## Product Change Notice (PCN)

PCN Number: PCN-045-0020R-01

Product(s) Affected: *PJ-072C-SMT-TR*

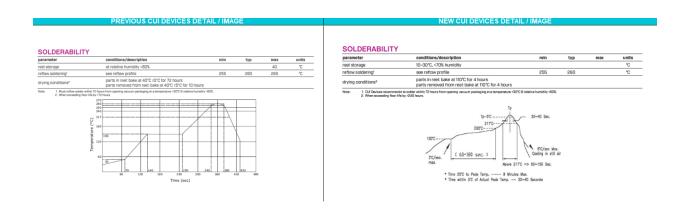
Description of Change: From PA6T to PA10T. Solder Profile Difference. See image Below
